Service Bulletin

No. : MZ07-086

Model: SA-7S1, SA-11S1, SA15S1, SA7001, SA8001

Subject: The software used for the first edition, **Non-RoHs-compliant** pickup.

How to identify pickup:

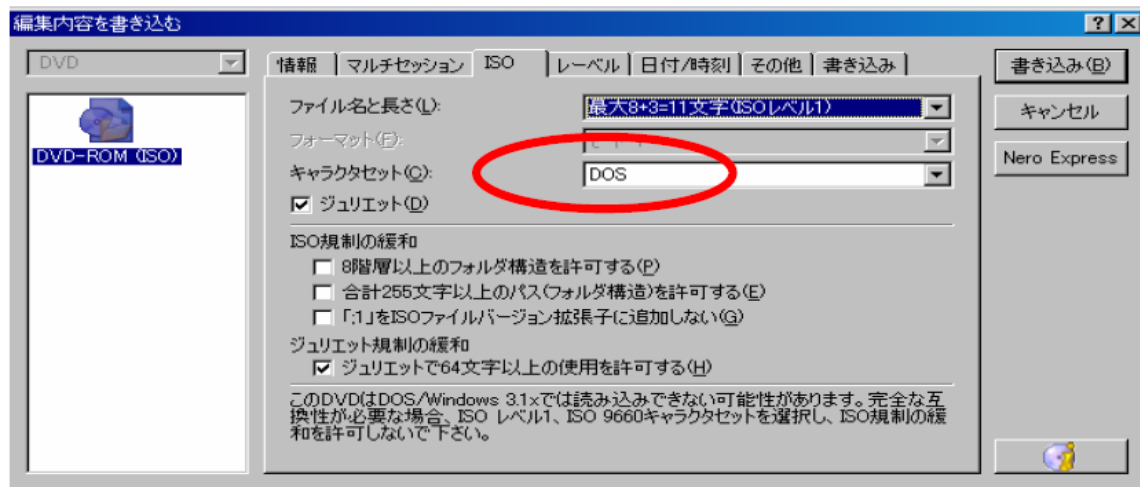
Symptom: This Software (firmware) was used for the mass production for **Non-RoHs-compliant** pickup.

RoHS compliant pickup

Non-RoHS-compliant pickup

Solution: Please refer to the service manual for “How to update Software”.

The update can be performed with a DVD-R disc. Please execute it as per the procedure laid down in the Service Manual for each model.
